DUGGAN MORRIS ARCHITECTS

job title					
BARTRAM'S HAMPSTEAD					
drawing title/location					
BASEMENT FLOOR PLAN					
status		PLANNING			
scale		1:100@A1	1:200@A3		
job no	source	zone	element	drawing no.	revision
A213	A		(01)	1 01	B

drawing title/location
LOWER GROUND FLOOR PLAN

drawing title/location
SECOND FLOOR PLAN

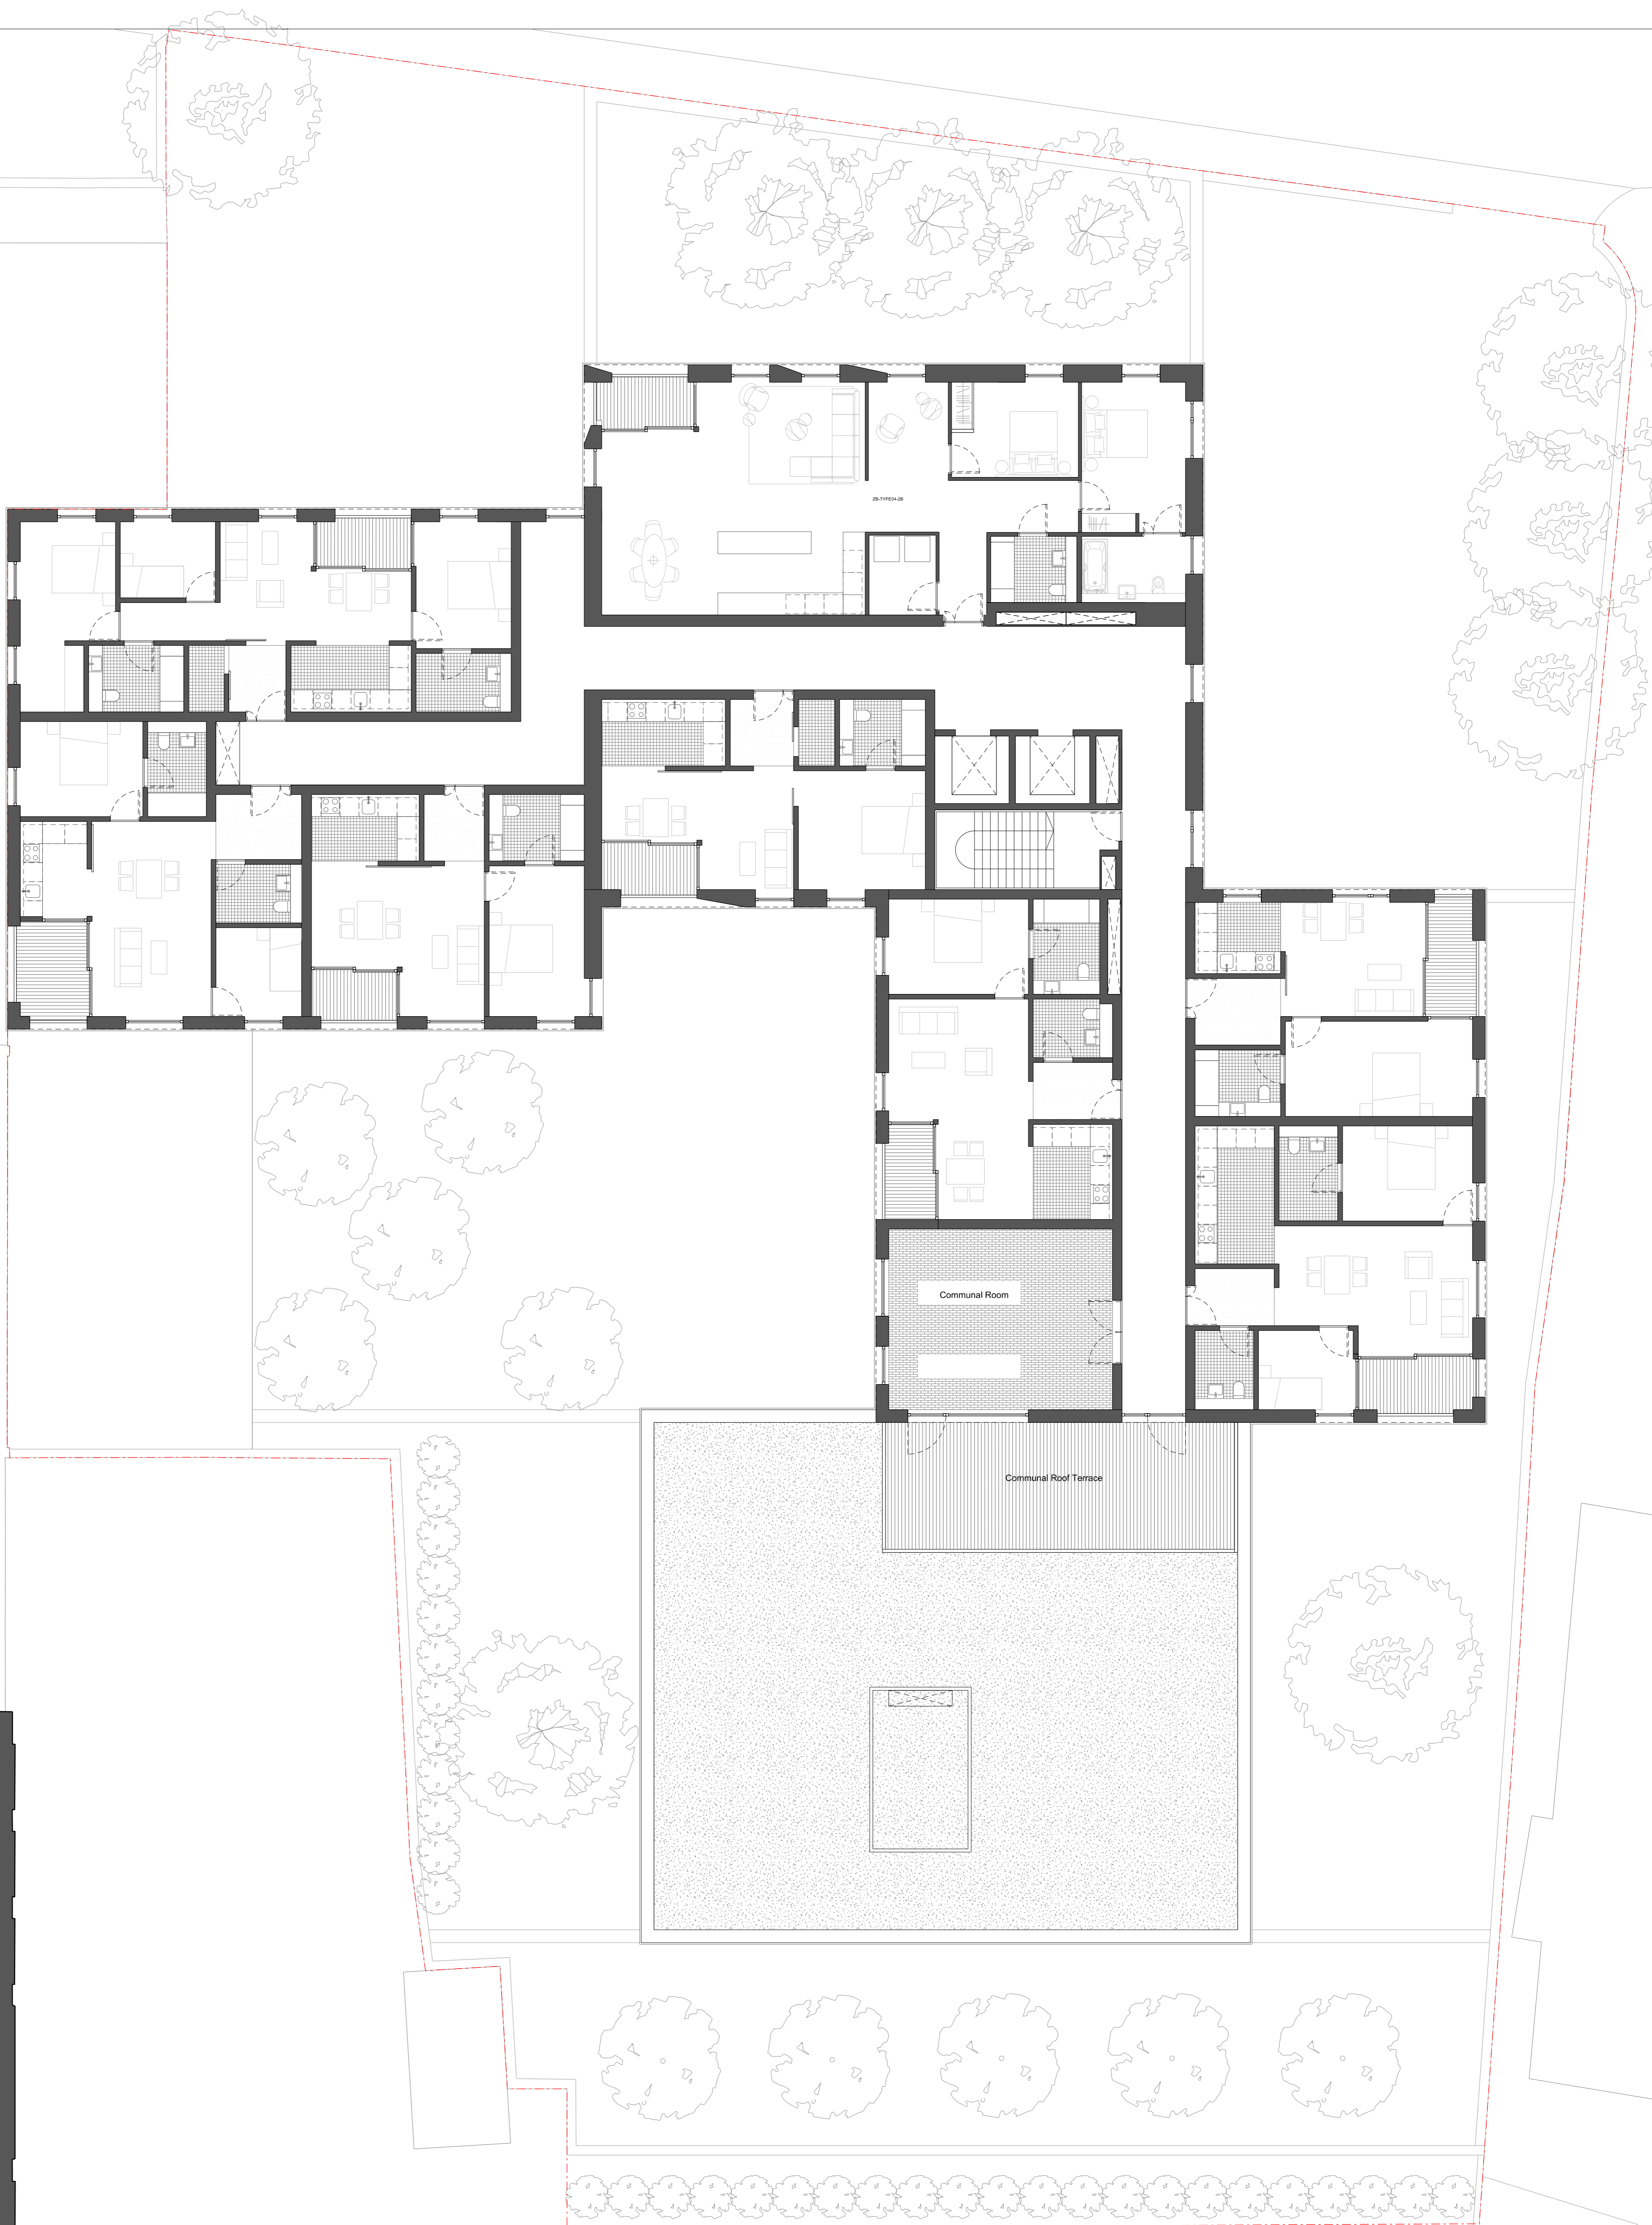
revision	date	amendment
A	10.04.15	Lift car amended to 1850mm x 1400mm
/	01.10.14	Submitted for planning

job title					
BARTRAM'S HAMPSTEAD					
drawing title/location					
FOURTH FLOOR PLAN					
status		PLANNING			
scale		1:100@A1	1:200@A3		
job no	source	zone	element	drawing no.	revision
A213	A		(01)	1 07	A

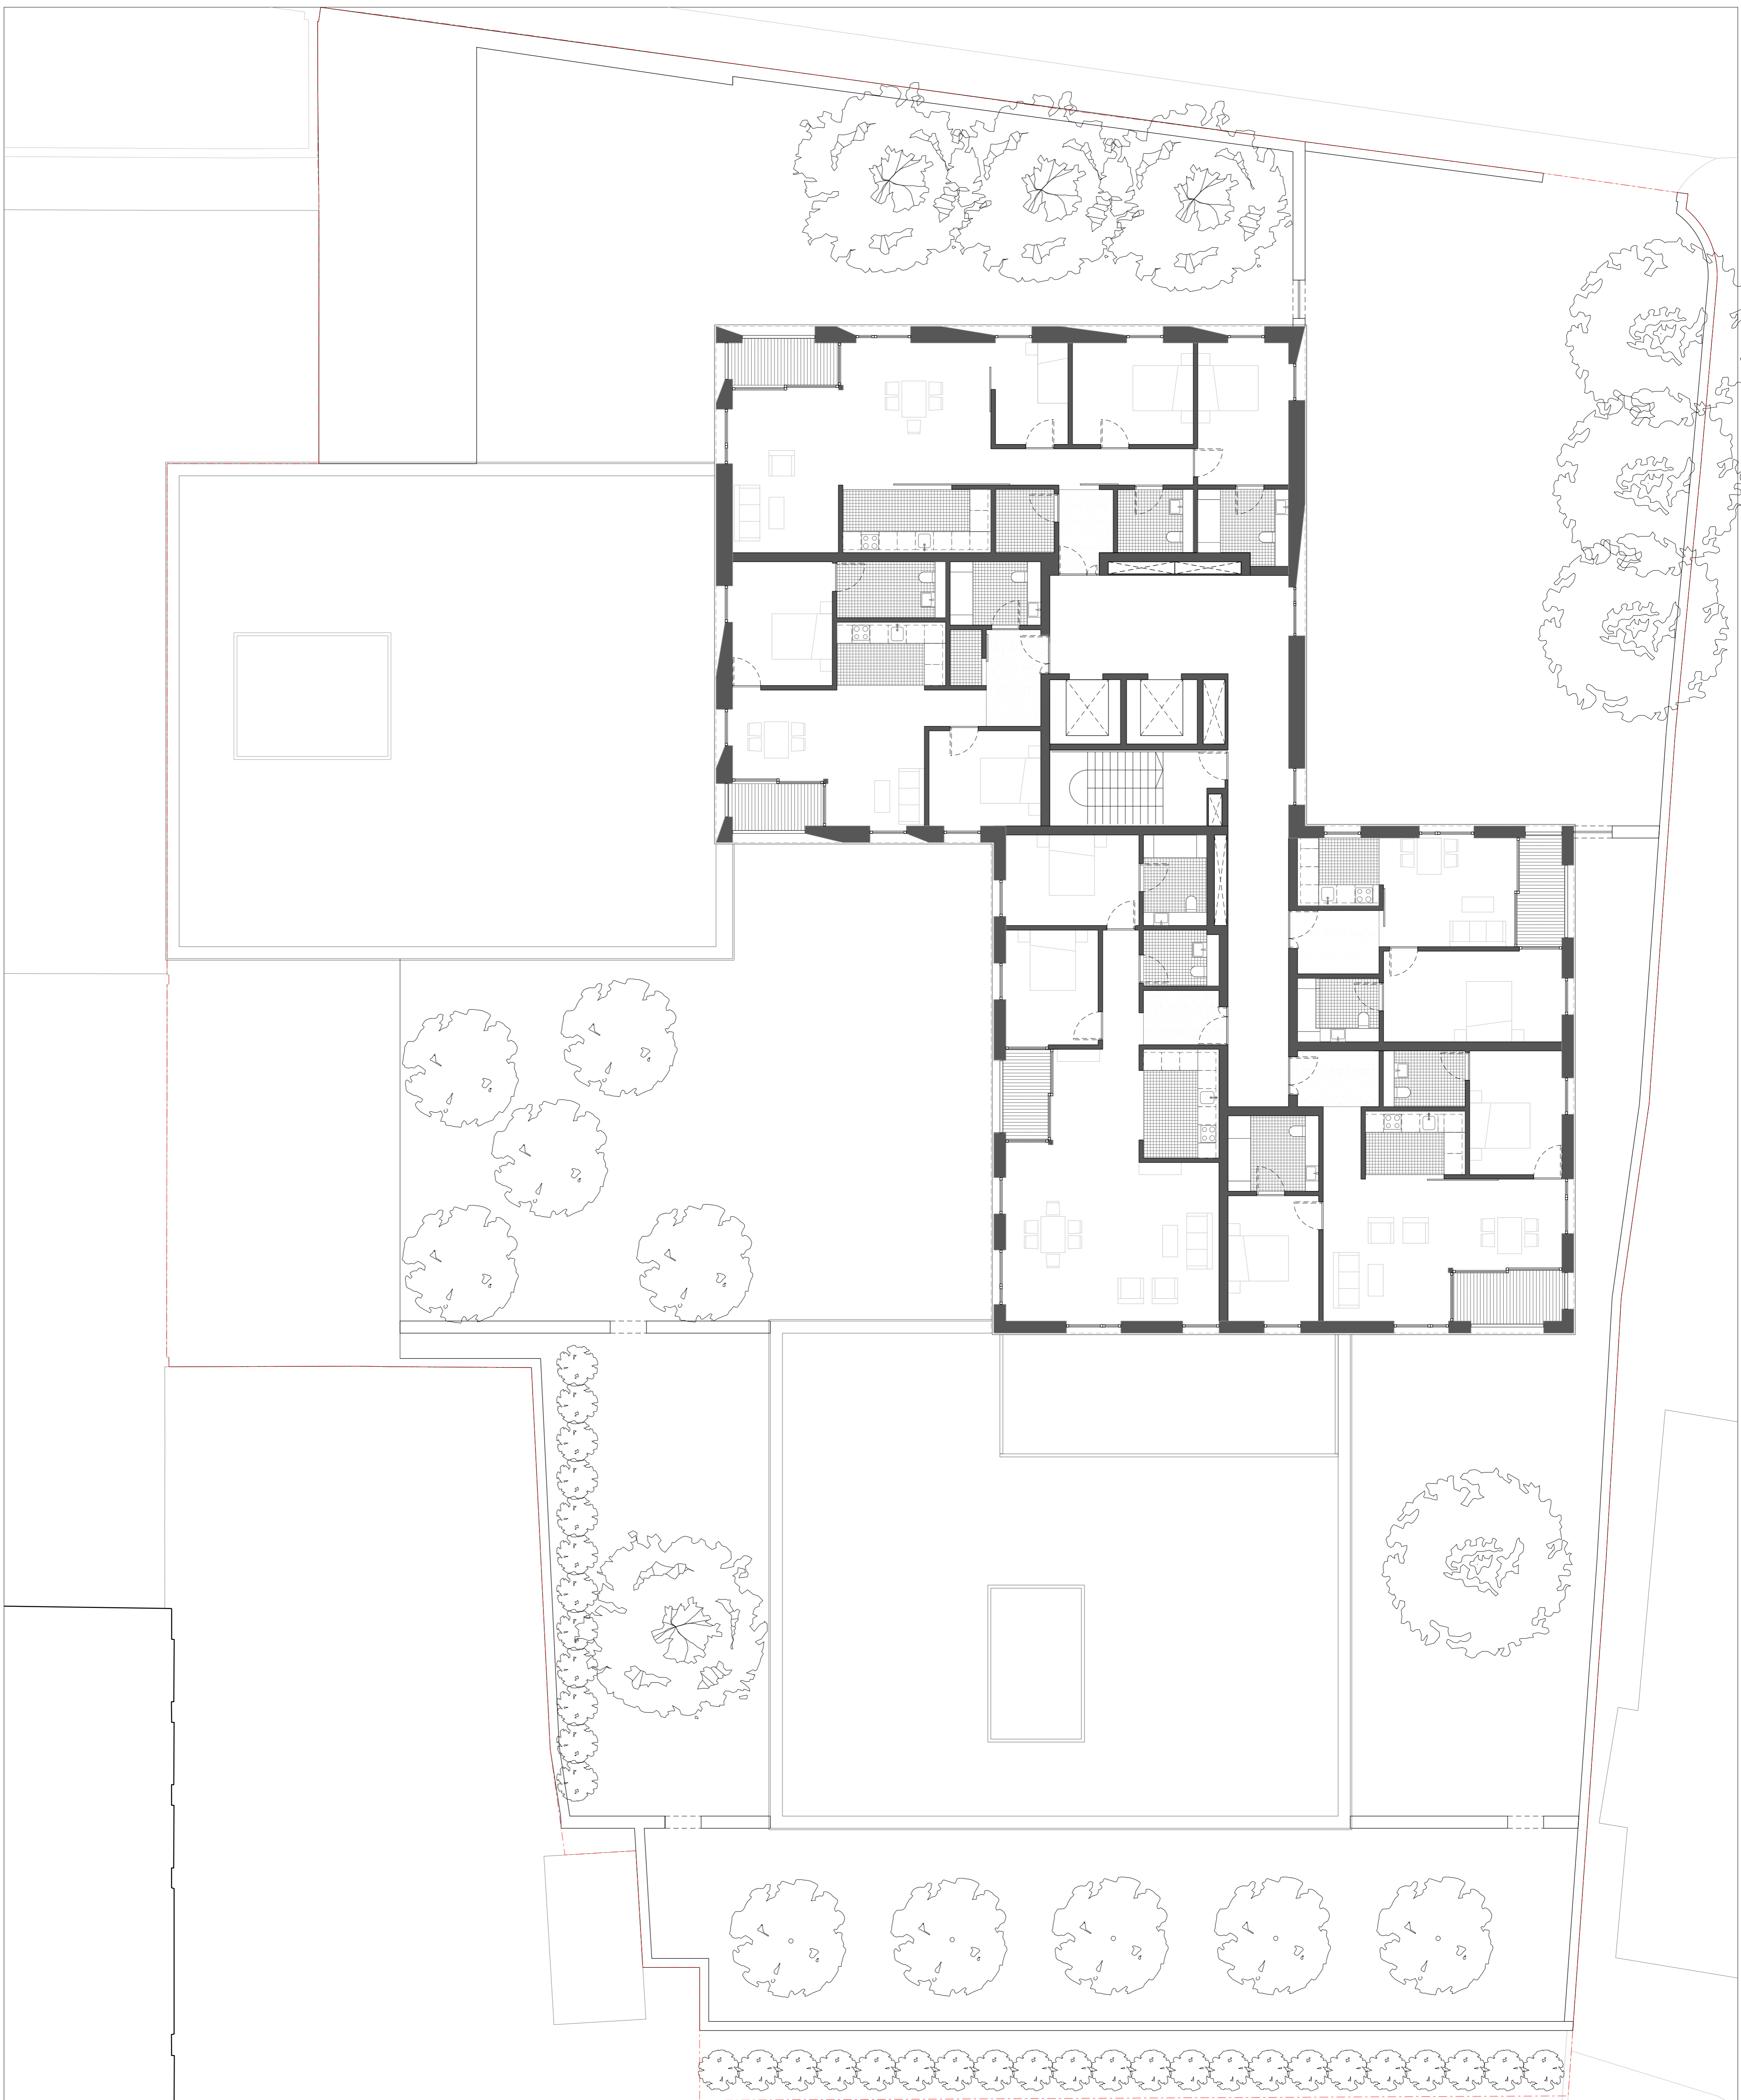
revision	date	amendment
A	10.04.15	Amended additional floor to block A. Lift core amended to 1850mm x 1400mm
/	01.10.14	Submitted for planning

drawing title/location
FIFTH FLOOR PLAN

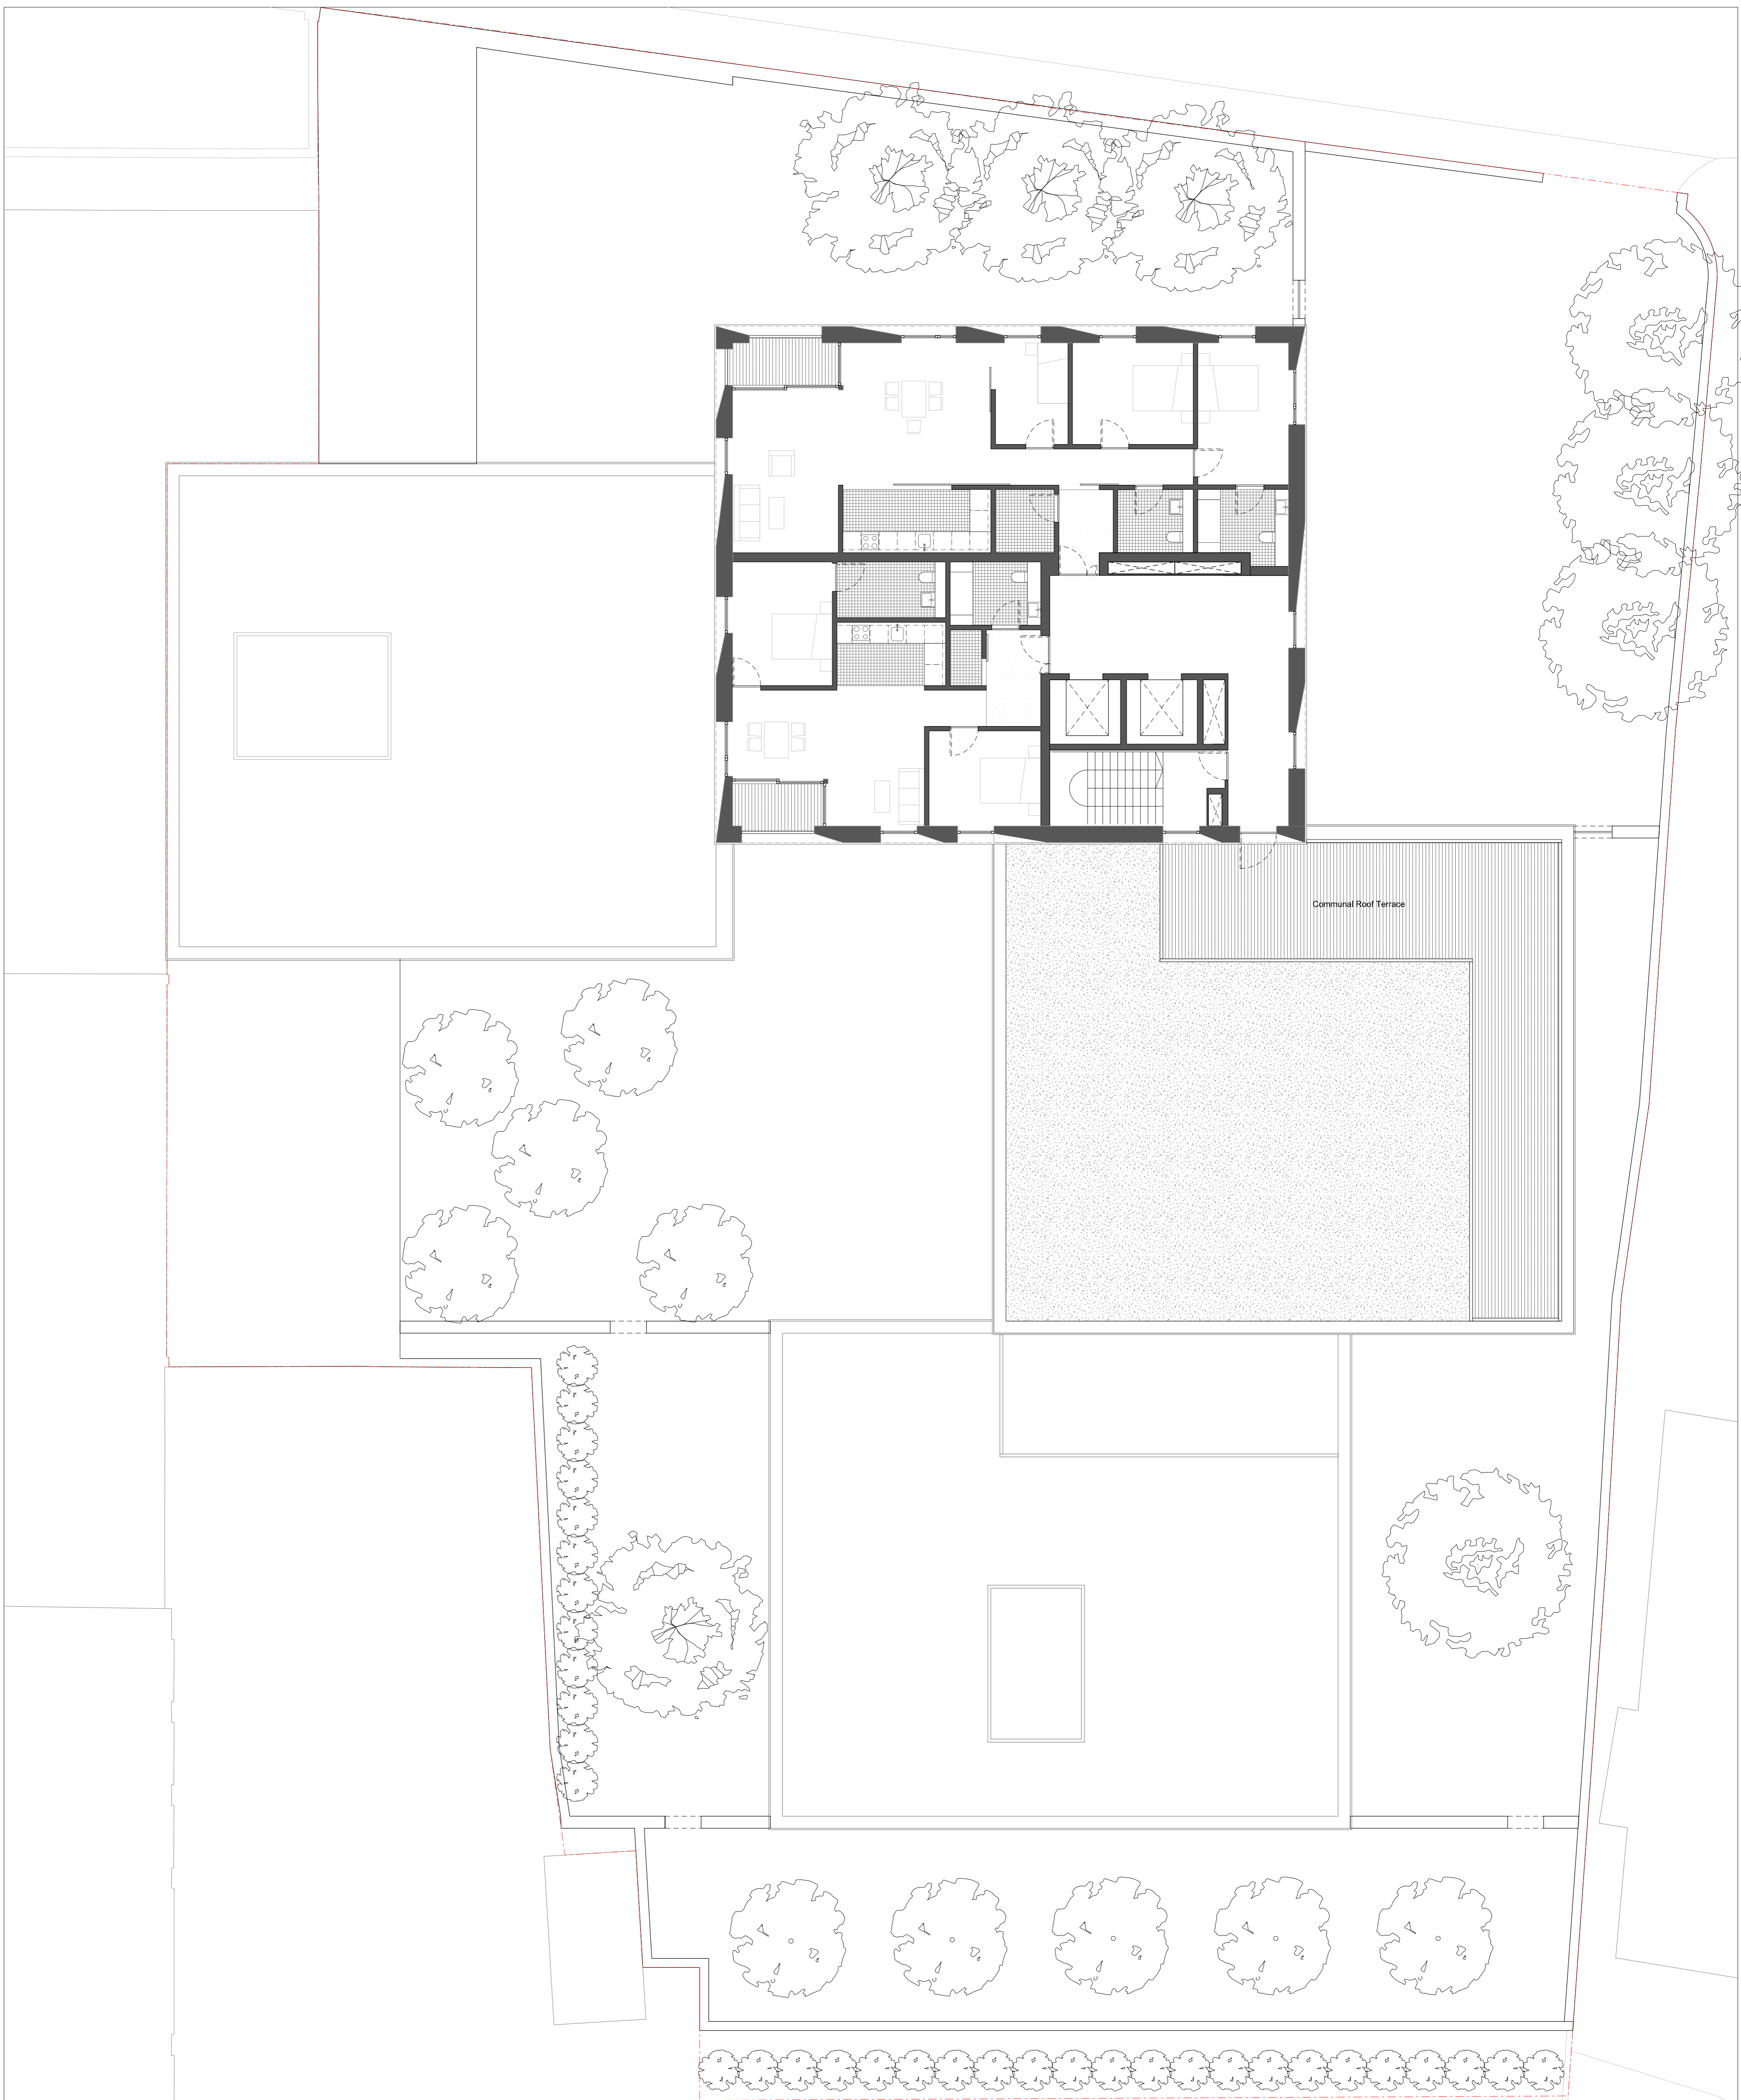
revision	date	amendment
A	10.04.15	Lift car amended to 1850mm x 1400mm
/	01.10.14	Submitted to planning
